APPLICATION FOR SUBMITTAL OF POST-APPROVAL DOCUMENT

ADDENDUM 1

Murrieta Mesa High School

MVUSD ATHLETIC LIGHTING UPGRADE

AD1 - E1.2

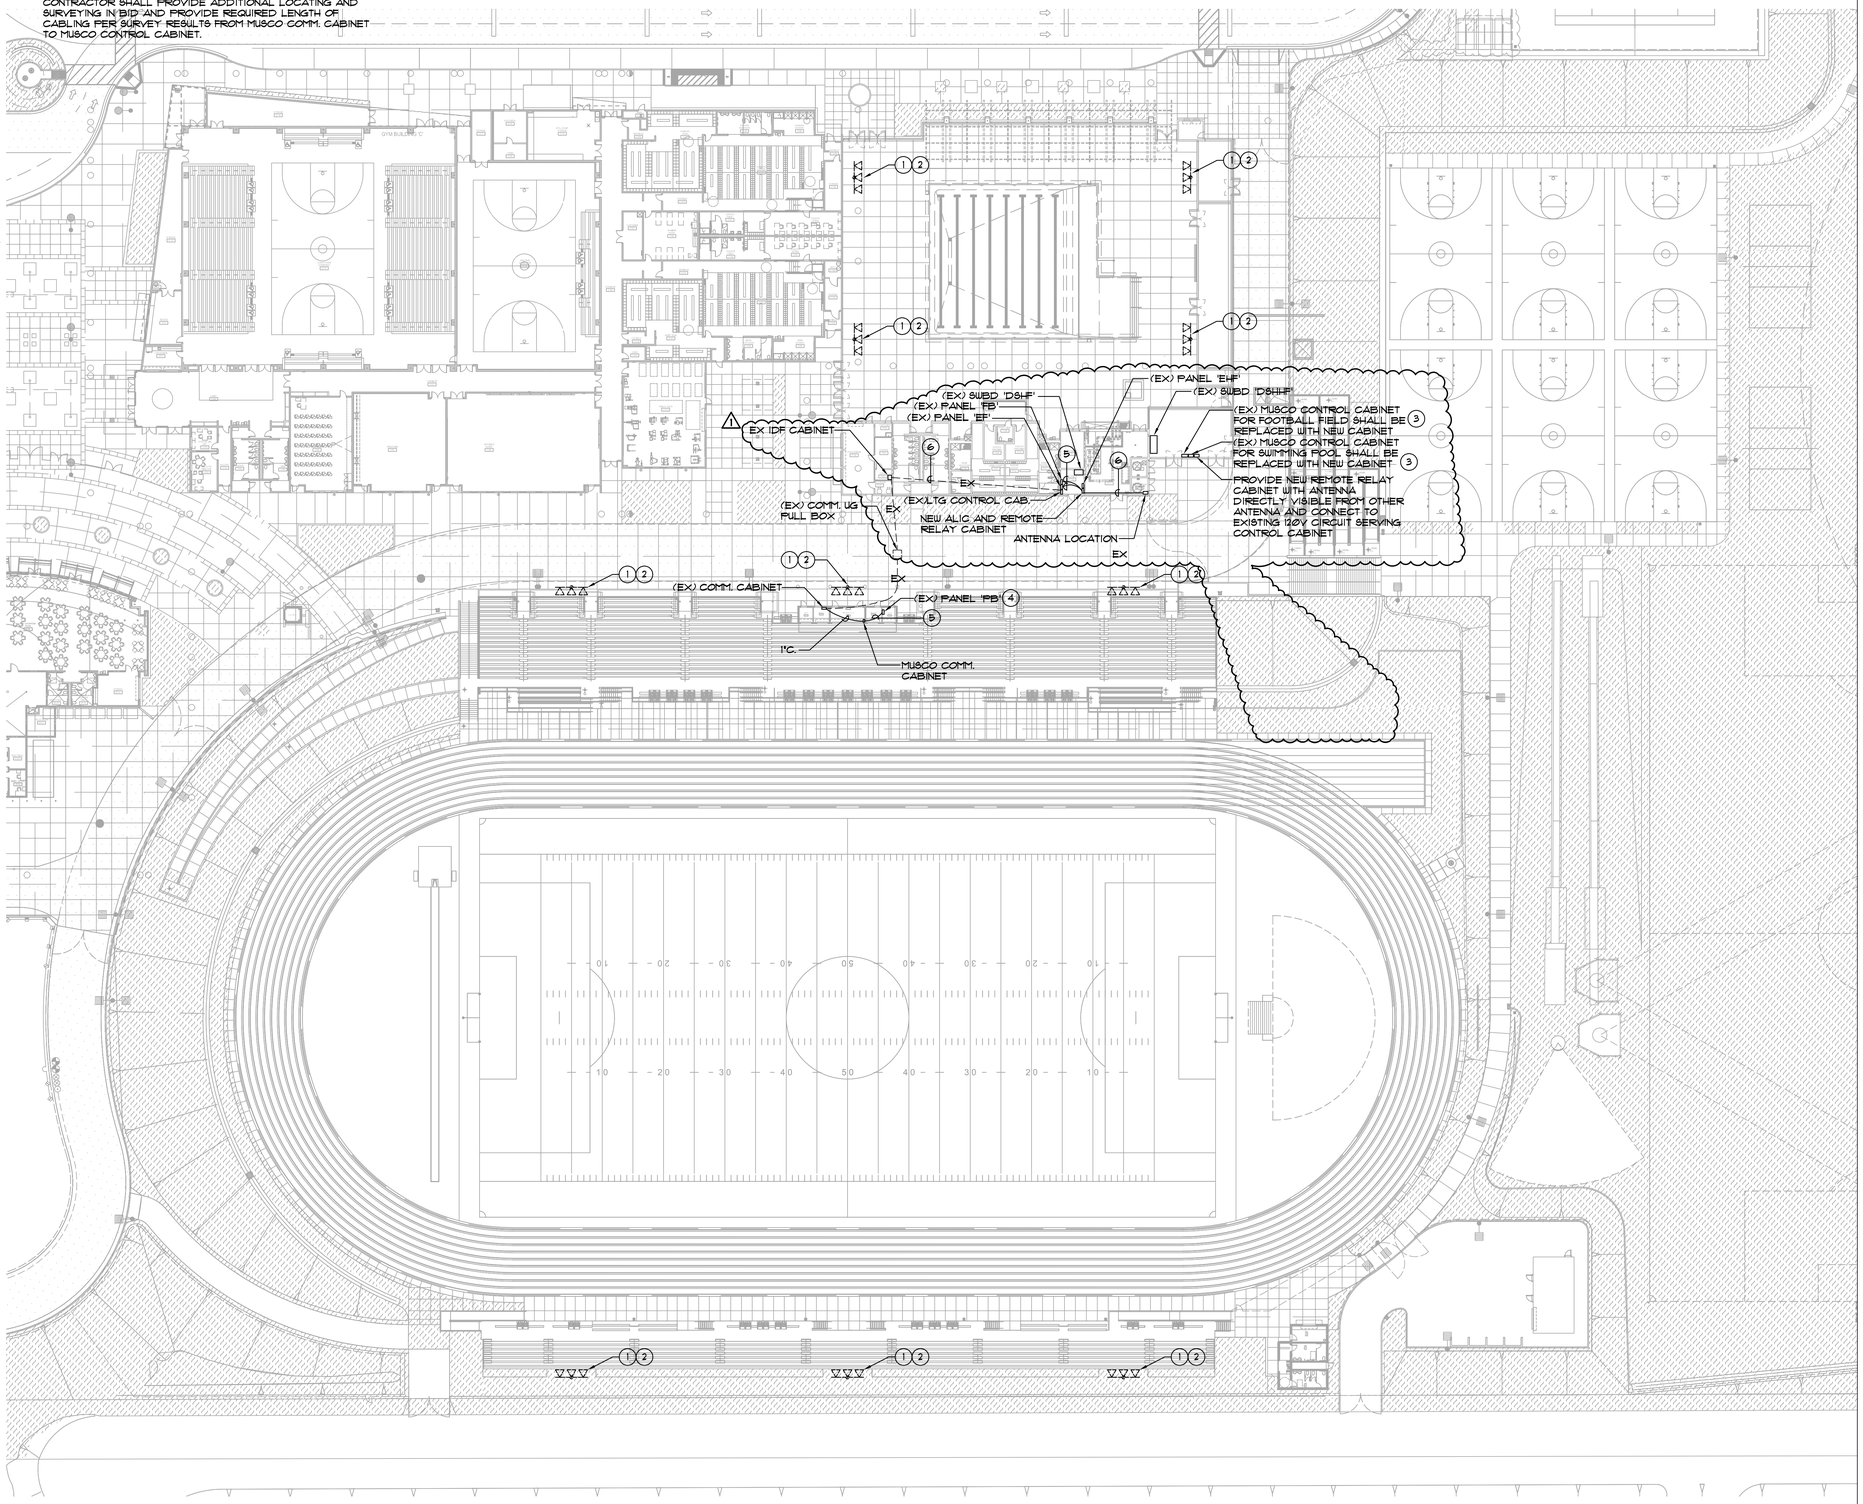
- **A.** Drawing E1.2 – ENLARGED SITE PLAN: Revised currently issued drawing per AD-E1.2
- **B.** Drawing E7.1 – SPORT LIGHTING ONE LINE DIAGRAM: Revised currently issued drawing per AD-E7.1

7. PROVIDE NEW 1"C. FROM REMOTE RELAY CABINET TO ANTENNA LOCATION. VERIFY EXACT LOCATIONS WITH MANUFACTURER.

AD1 - E7.1

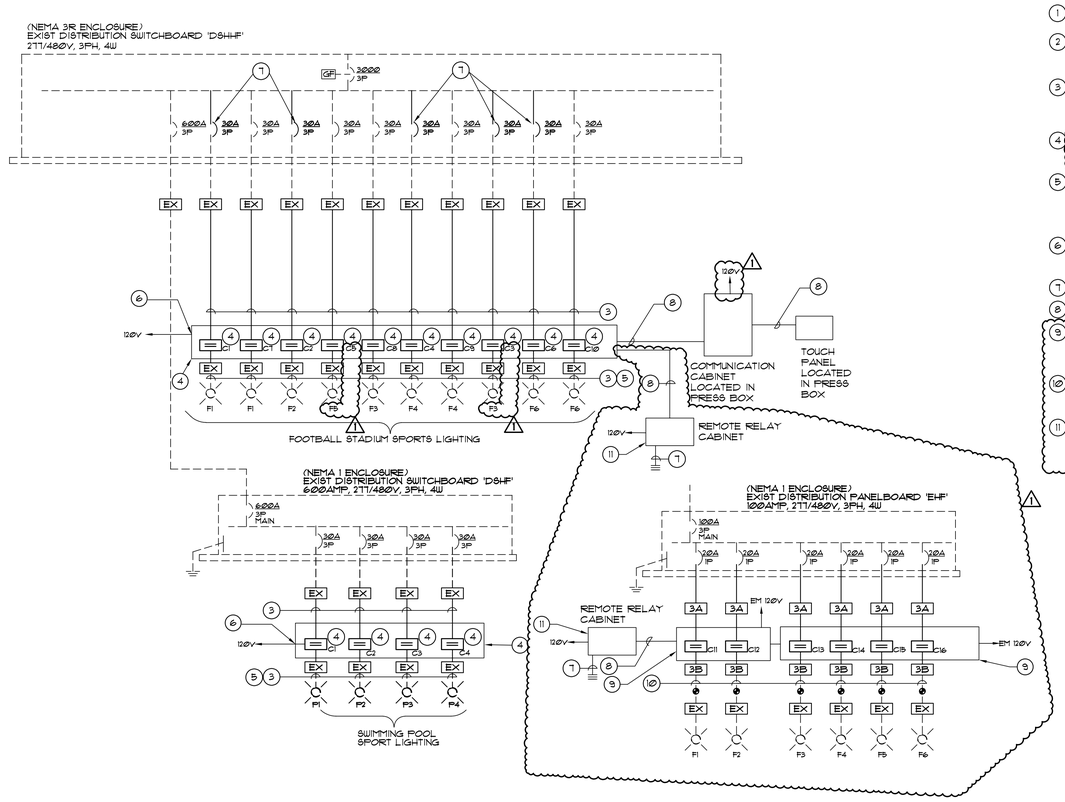
10. INTERCEPT EXISTING CONDUCTORS AND ROUTE NEW CONDUCTORS FROM ALIC THROUGH THE EXISTING CONDUITS OUT OF PANEL EHF.
11. PROVIDE REMOTE RELAY CABINET AND 1"C. FROM CABINET TO ANTENNA LOCATION. VERIFY EXACT LOCATION WITH MUSCO AS REQUIRED. ANTENNAS MUST BE IN DIRECT LINE OF SIGHT OF EACH OTHER.
